ADDENDUM # 001

ST. CLAIR CATHOLIC DISTRICT SCHOOL BOARD
ST. JOHN FISHER CATHOLIC SCHOOL

TENDER NO.: 632-CP1505

Issue Date:
Wednesday May 13, 2015

A100 –FLOOR PLAN, DETAILS & INTERIOR ELEVATIONS

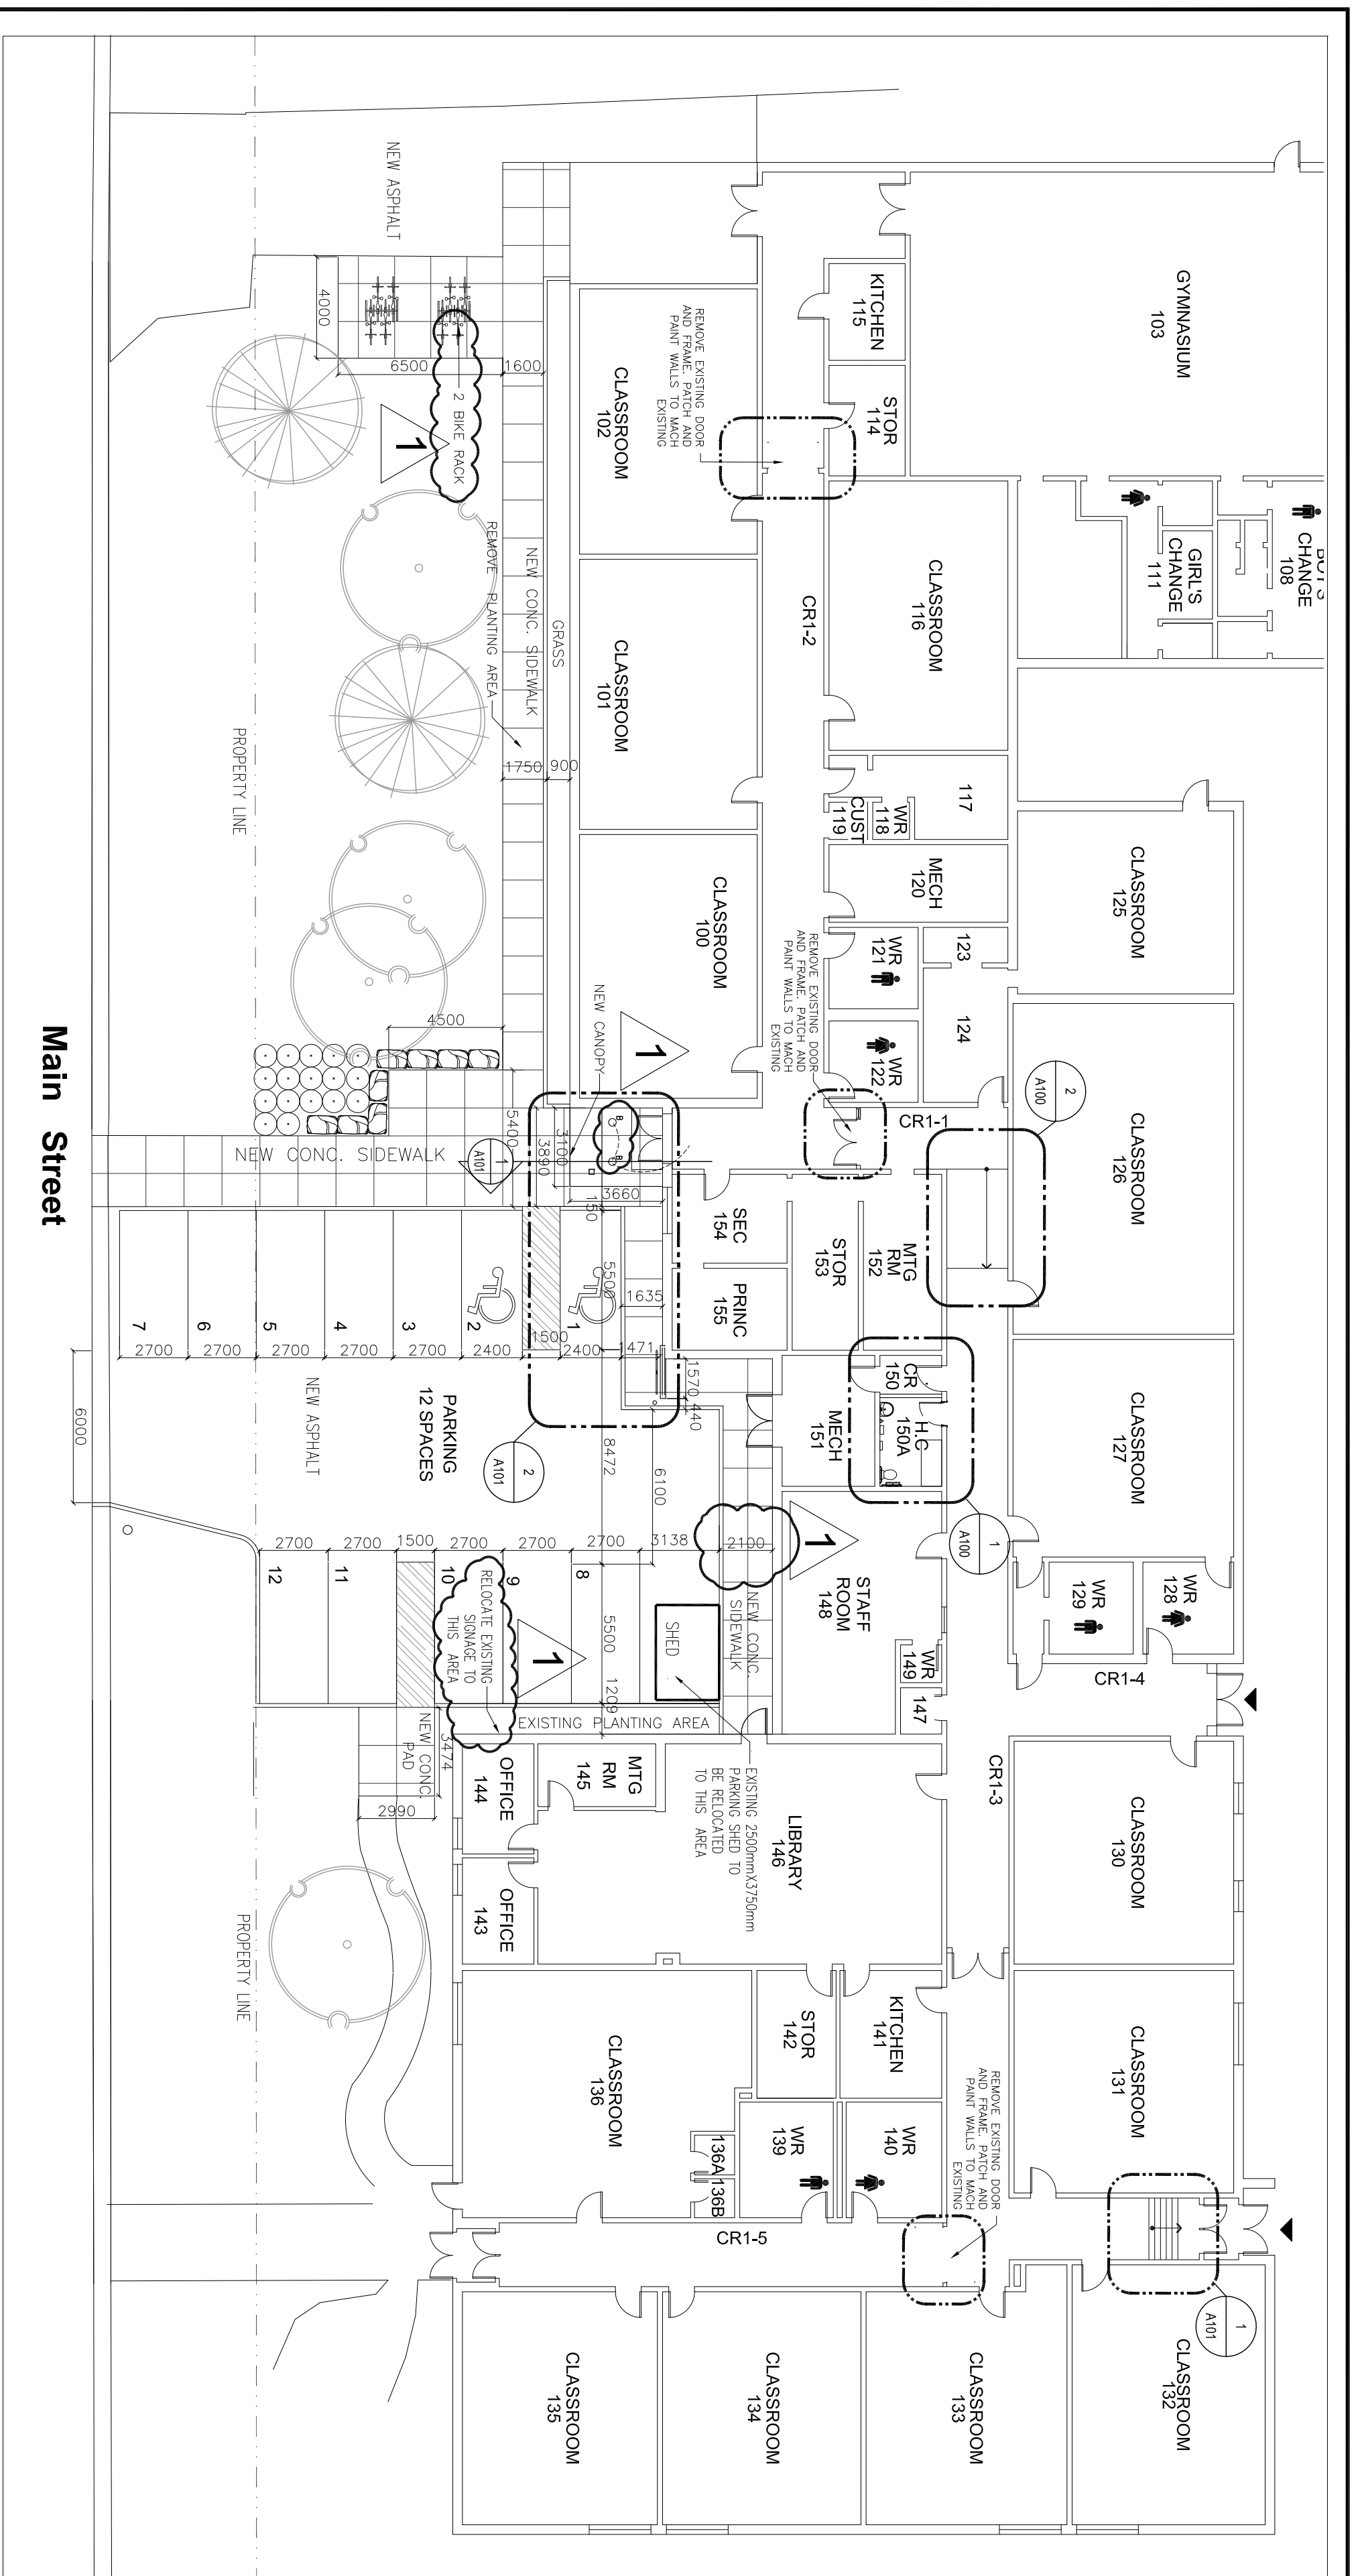
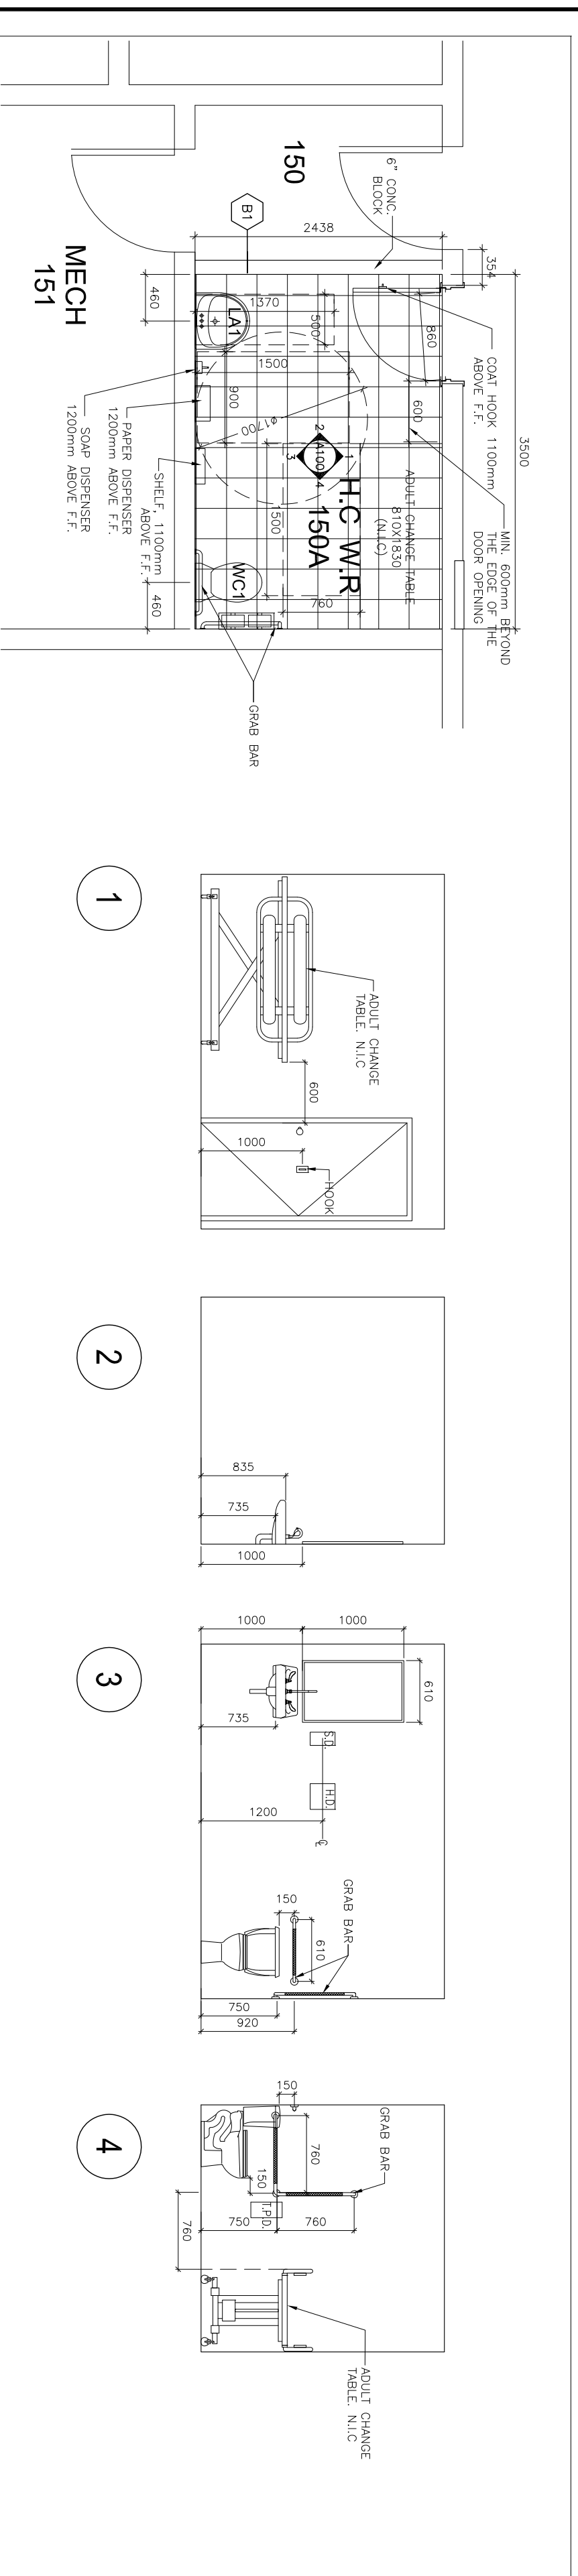
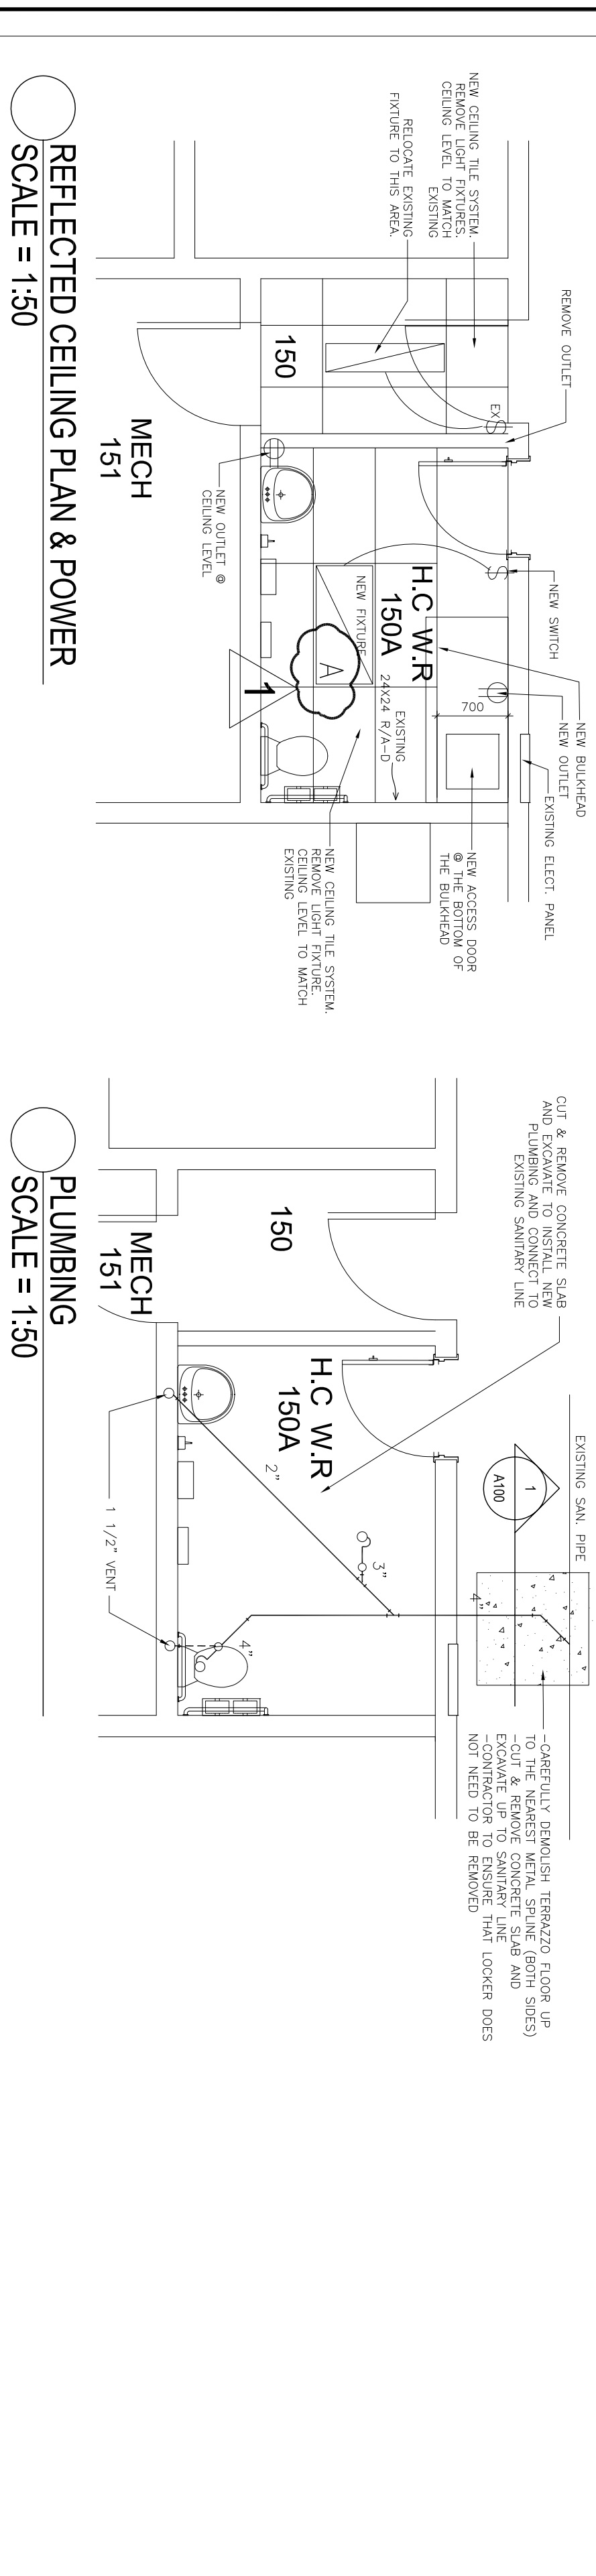
Refer to revision clouds and addendum 1 tags for changes to drawing.
